Draft Safety Evaluation Report

related to the final design approval
and design certification of the
Advanced Boiling Water Reactor

Docket No. 50-605
General Electric Company

U.S. Nuclear Regulatory
Commission
Office of Nuclear Reactor Regulation
August 1989

Figure 1-1

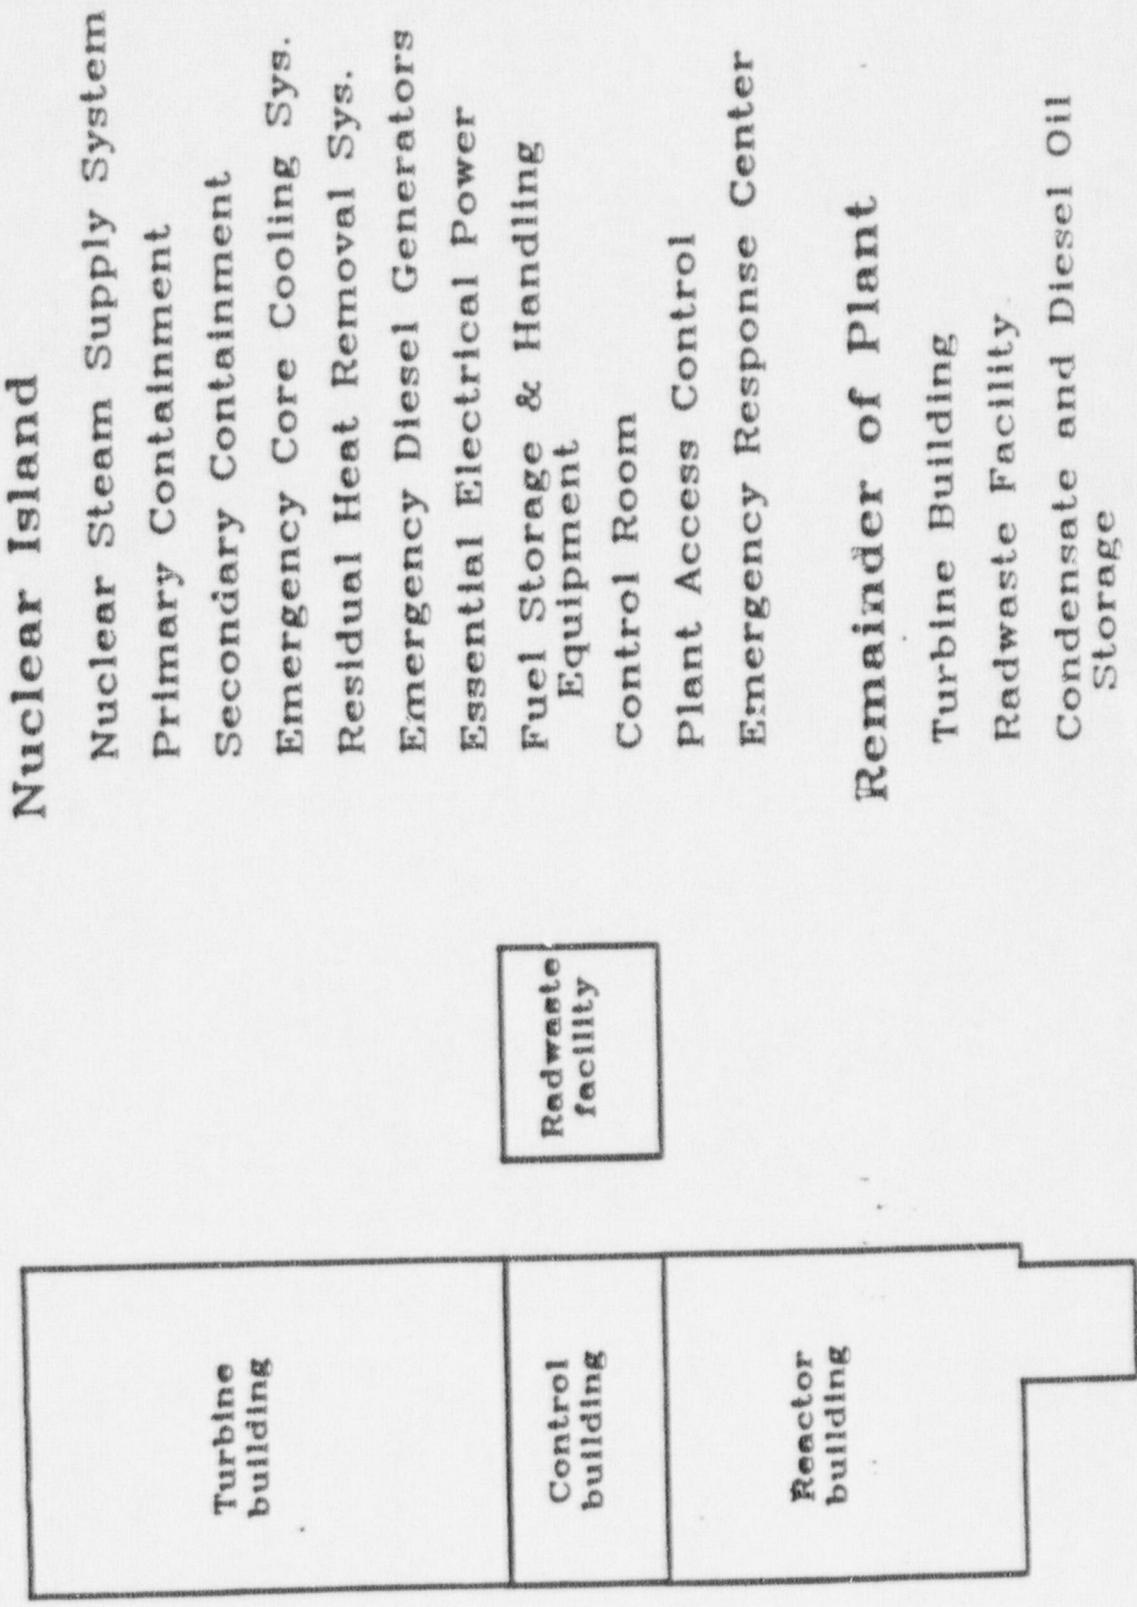
The scope of the ABWR standard design, as illustrated in Figure 1-1, is a nuclear island. The SAR is to include all of the information necessary for the staff to complete its SER. This includes interfaces (design, construction, testing and operational) between the ABWR standard design and the remainder of plant. GE may later expand its submittal to include some or all of the remainder of plant.
